### **DOWNTOWN RECOVERY PLAN UPDATE**

#### RECOMMENDED DEVELOPMENT STANDARD AMENDMENTS

City of Santa Cruz Planning Commission Meeting

June 15, 2017

Figure E-1, page 59, Redline version

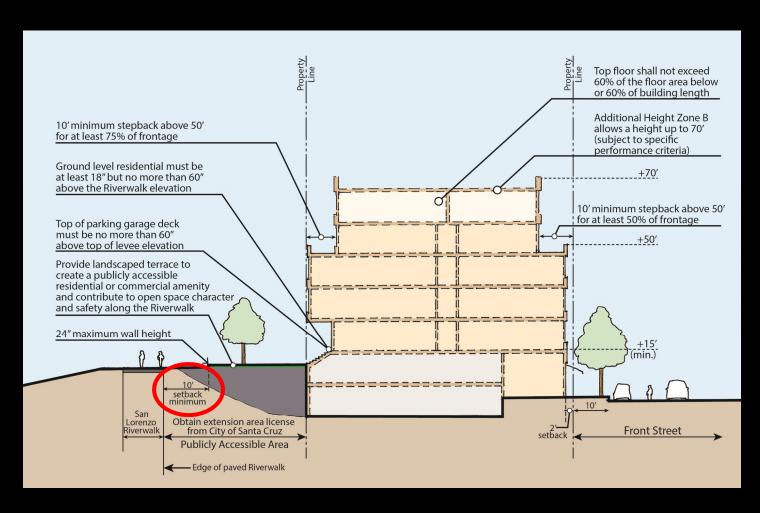
Existing Text (Was proposed for deletion in 2016)

SRFA-2 Maintain the ten-foot setback area between residential and commercial uses adjacent to the levee trail from the western edge of the trail. The area should be filled to raise the adjacent ground-level use to the same elevation as the levee trail. This area should also incorporate outdoor public seating or visually accessible garden space for residential development. Trees planted as part of the San Lorenzo Flood Control Improvement Project should be maintained and incorporated into new development.

• SRFA-2 Maintain the ten-foot setback area between residential and commercial uses adjacent to the levee trail from the western edge of the trail. The area between the property line and the Riverwalk shall be filled to raise the adjacent ground-level use to a similar or higher elevation as the Riverwalk. The public lands between the Riverwalk and the private property may incorporate publicly accessible commercial or residential amenities, such as outdoor public seating. Trees planted as part of the San Lorenzo Flood Control Improvement Project should be maintained and incorporated into new development where feasible and where not in conflict with the required fill or publicly accessible amenities.

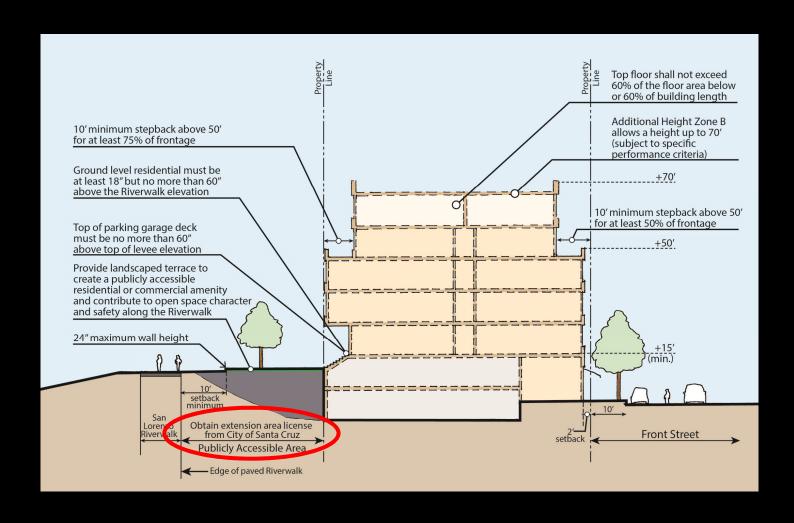
• SRFA-2 Maintain the ten-foot setback area between residential and commercial uses adjacent to the levee trail from the western edge of the trail. The setback area between the property line and the Riverwalk should shall be filled to raise the adjacent ground-level use to the same a similar or higher elevation as the levee trail Riverwalk. This The public lands between the Riverwalk and the private property may area should also incorporate publicly accessible commercial or residential amenities, such as outdoor public seating or visually accessible garden space for residential development. Trees planted as part of the San Lorenzo Flood Control Improvement Project should be maintained and incorporated into new development where feasible and where not in conflict with the required fill or publicly accessible amenities.

Figure H-7: Example of distribution of frontage heights and horizontal massing variation along Front Street.

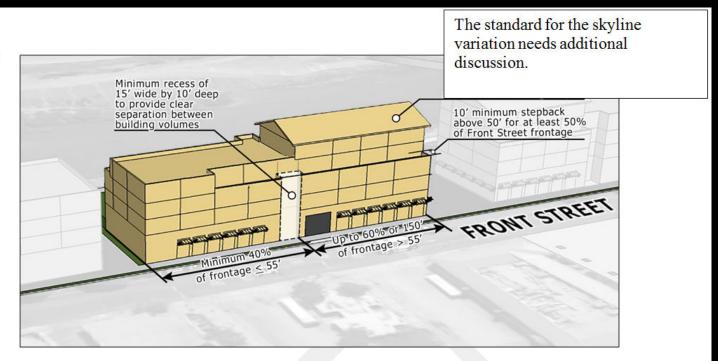
ii. Skyline Architectural Variation. To promote skyline variation, the top floor of any building shall not exceed 60% of the floor area below or 60% of the building length as measured along Front Street or the Riverwalk. Variation to the 60% floor area standard can be considered for projects that incorporate publicly accessible pedestrian connections to the Riverwalk.
